## COUNCIL ASSESSMENT REPORT

| <b>Panel Reference</b>                                                                             | PPSSCC-127                                                                                                                                                                                                                                                                                                                                                                                                                                                                                                                                                                          |
| <b>DA Number</b>                                                                                   | DA 179/2021/JP

**Figure 1: Height plane – indicated in red (Source: Tiba Architecture Group 3/11/20)**

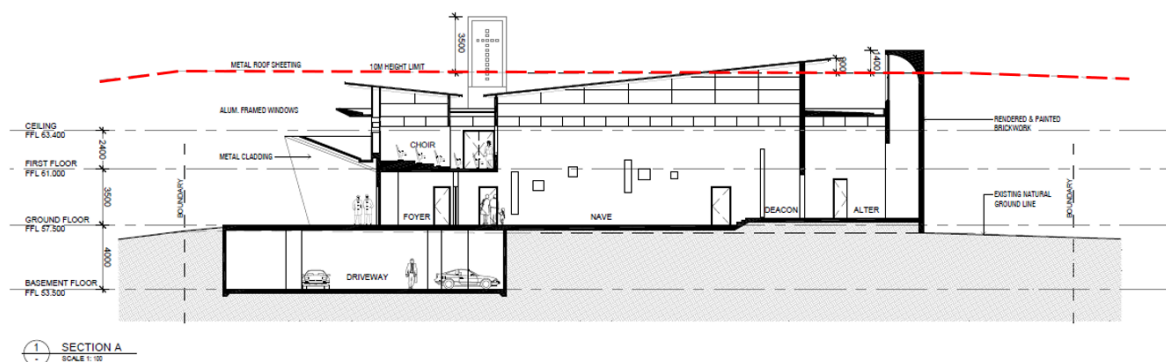
Assessment of the Clause 4.6 variation request has been undertaken and it is considered that the height variation itself does not result in unreasonable or negative amenity impacts to adjacent properties. It is accepted that the tower elements are characteristic of a place of public worship and there are sufficient planning grounds to justify contravening the development standard to accommodate these design features. The extent of the height variation is demonstrated in **Figure 1** below.

The only components of the development which exceed the 10m height control are the tower feature, part of the roof of the main church roof and the walls behind the altar.

No evidence has been provided by the applicant with respect to whether alternative building placement and/or compliant roof designs have been considered. Notwithstanding, it is considered appropriate to provide an element of flexibility in applying the maximum building height standard to accommodate a bell tower element as proposed to signify the use of the

**Figure 2: Northern elevation (Source: Tiba Architecture Group 3/11/20)**

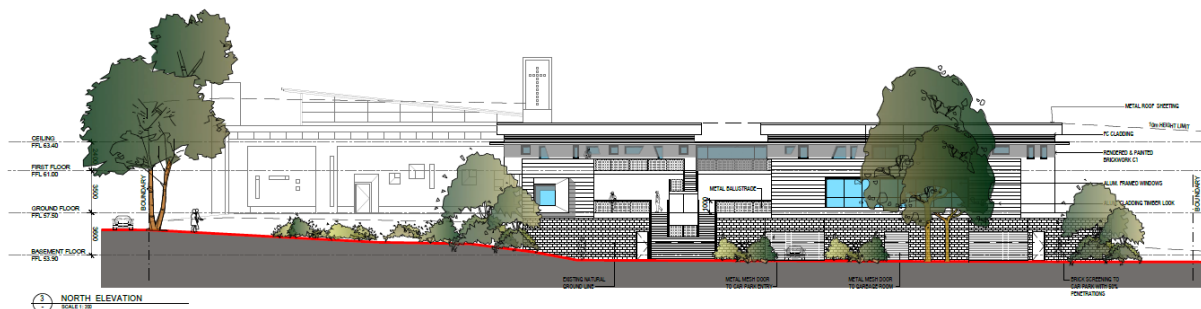
The proposed development locates built form elements on the western side of the site, closest to adjoining residential properties and the tallest elements are placed on the highest points of the site, amplifying their visual dominance.

The alteration to the natural ground level in order to create the basement car park is inconsistent with the low density residential character of the locale. The height of the basement wall above the natural ground level particularly on the Raymond Court frontage of the site is also excessive and will dominate this streetscape. The hall building will present as three (3) storeys on that frontage as shown in **Figure 2** below. This component of the development will be visually dominating and would result in development which is out of character with the surrounding area.

**Figure 3: Eastern cross section – natural ground level in red (Source: Tiba Architecture Group 3/11/20)**

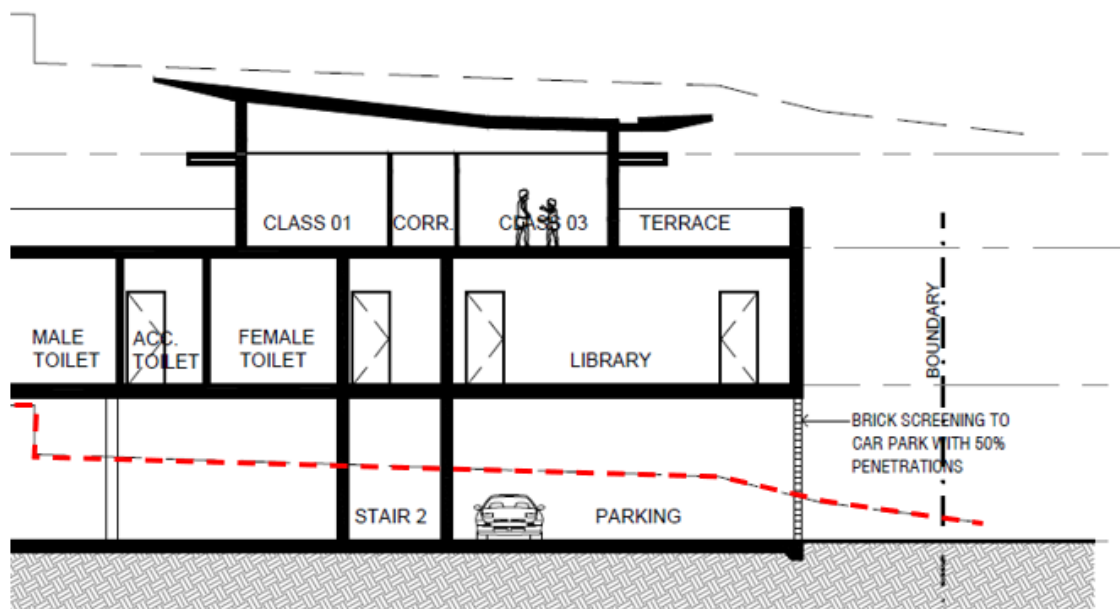
The basement wall at its northern end facing Raymond Court appears to be more than one (1) metre above the natural ground level which is an unacceptable built form outcome in a low density residential area. **Figure 3** below shows the natural ground level in red.

The proposed design and scale of the development is inconsistent with the surrounding low density residential character and is not considered to be compatible with the existing streetscapes, especially Raymond Court. The inappropriate bulk and scale is a source of considerable public concern as evidenced in the submissions received.
